Product Notice

PN 637

Models Affected: XT Pro

SUBJECT: *Non-sealed Outrigger Switches*

Figure 5 – Chip Box Solenoid Connectors

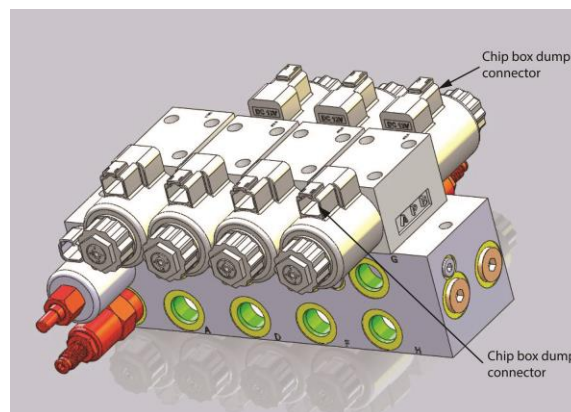
1. As soon as the unit is leveled with the outriggers, move the selector switch to the “UNIT” position. Keep the switch in this position anytime the boom is elevated or occupied.
2. Turn the master switch for the PTO off any time the unit is not in use, including during breaks and travel. Do not depend on the parking brake interlock to disable the system.
3. Avoid exposing these switches to water.
4. If the chip box attempts to move, remove the connectors from the chip box valve solenoids as shown in figure 5. Reconnect when its required to dump chips.
